Perspective - Tingey Square - Looking Northwest

ZONING COMMISSION HEARING - MAY 23RD, 2019

REVISED SUBMISSION - MAY 30TH, 2019

Photo of Materials

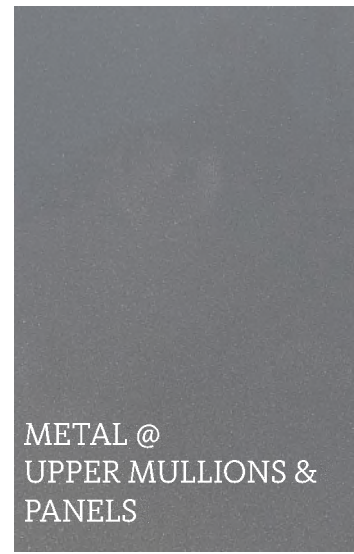
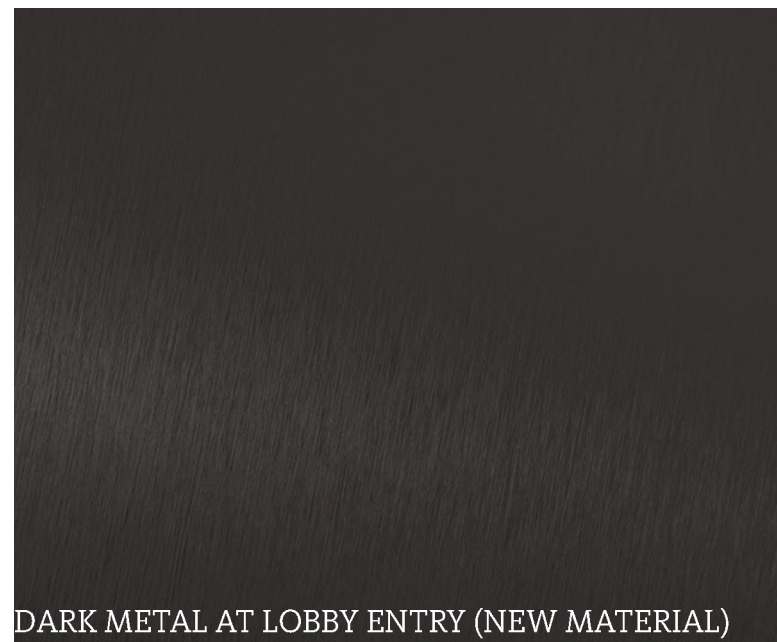
PREVIOUS BRICK SELECTION

REVISED BRICK SELECTION
